**LINCOLN CITY/LANCASTER COUNTY PLANNING STAFF REPORT**

**PROJECT #:** Special Permit #06052

**PROPOSAL:** Special Permit for a Community Unit Plan of approximately 61 acreage lots.

**LOCATION:** Northeast of S. W. 70<sup>th</sup> Street and W. Van Dorn Street

WEST VAN DORN HEIGHTS ASPEN BUILDERS

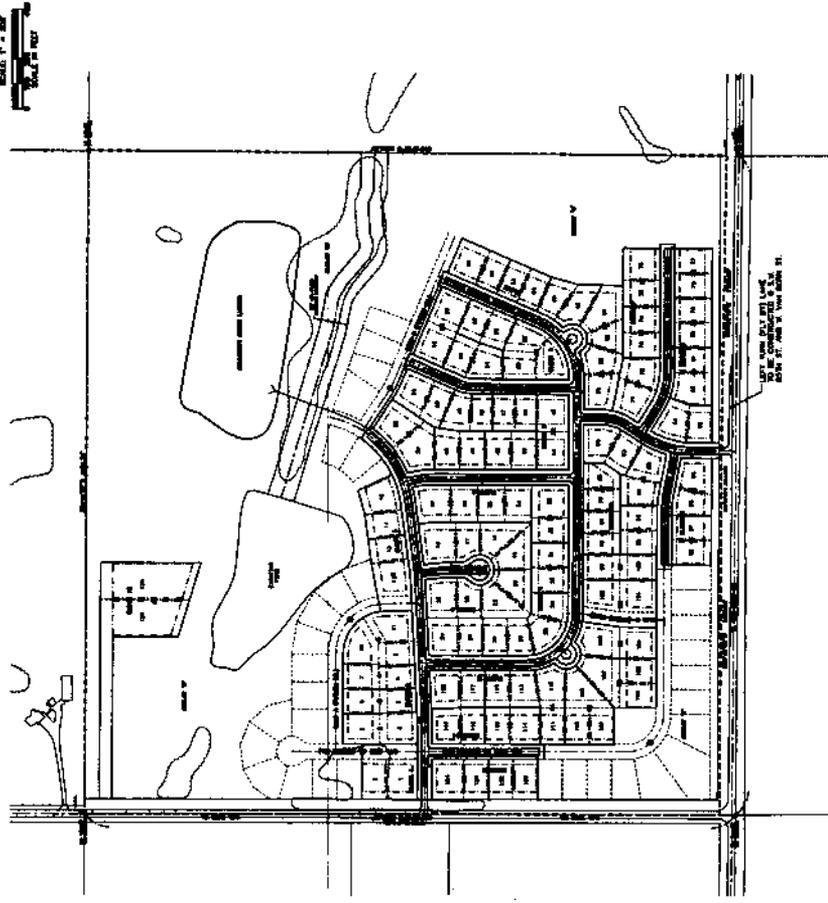
- 4.1.1.1 Make the revisions noted in the County Engineers memo of September 7, 2006.
- 4.1.1.2 Make the revisions in the Public Works memo of September 14, 2006.
- 4.1.1.3 Call out and dimension all easements.
- 4.1.1.4 Remove the A,B,C designators on future roads.
- 4.1.1.5 Show future street connections to S.W. 70<sup>th</sup> and to W. Van Dorn at the ½ mile line.
- 4.1.1.6 Show and call out all building envelopes.
- 4.1.1.7 Show the flood pool elevation of the pond.
- 4.1.1.8 Renumber the lots and blocks per the subdivision ordinance.
- 4.1.1.9 Show the tree masses to be removed and retained.
- 4.1.1.10 Add the use and future use reservation for future residential development to the appropriate outlots. Include density.

- 4.1.1.11 Show the calculations of building coverage per the BTA.
  - 4.1.1.12 Show the acreage of the outlots.
  - 4.1.1.13 Show easements for future sewer and storm sewer.

- 4.1.1.14 Amend note on waivers to reflect the preliminary plat.
  - 4.1.1.15 Amend note #7, page 4 that stormwater detention standards are met.
  - 4.1.1.16 Show a drainageway, future storm sewer and future sanitary sewer easement along the creek in Outlot "C".

- 4.1.1.17 Show the dimension of all R.O.W.
  - 4.1.1.18 Note where each typical road cross section applies.
  - 4.1.1.19 A permanent final plan with 5 copies as approved.

- 6) *General Note 32* should be revised since there is no flood plain on the property.
- 7) *General Note 33* is not needed in light of *General Note 19*.

- 10) The minimum culvert size under the roadway is 24". Culvert 2 and 10 are too small.
- 11) Drainage area hydrology and culvert hydrologys shall be included on the drainage plans.
- 12) The maximum profile grade is 7.0%. The grade of 8.0% on West Hallowell Lane is too steep.
- 13) The approach grade of SW 65<sup>th</sup> Street (south leg) at West Remington Drive should be 3.0% or less.
- 14) The radius of the returns at NW 70<sup>th</sup> Street and at West Van Dorn Street shall be 50 feet. Interior returns shall have 30 feet radius.

Comments: Site Plan shows three "future roads" with names Road A, Road B and Road C. We have denied two other developers request for these names and will continue to do so. Lettered streets A through Z are well established and any variation will only lead to confusion and a danger to the Public.

Does West Remington Drive change at the intersection of SW 66th or at the cul-de-sac? Clarify on the plat.  
Probably better at the cul-de-sac.

- The easement for the future trunk sanitary sewer needs to be shown along the existing channel.
- The possible future detention areas need to be shown and labeled on the plans. If the existing pond is intended to serve as the future detention cell, this needs to be indicated on the plans.

- The public access easements for the private roadways need to be clearly labeled and dimensioned on the plan sheets.
- The future roads shown on the build through plan need to be labeled with easements or platted as outlots to ensure that these required roads are able to be constructed when the development is further subdivided into urban density.
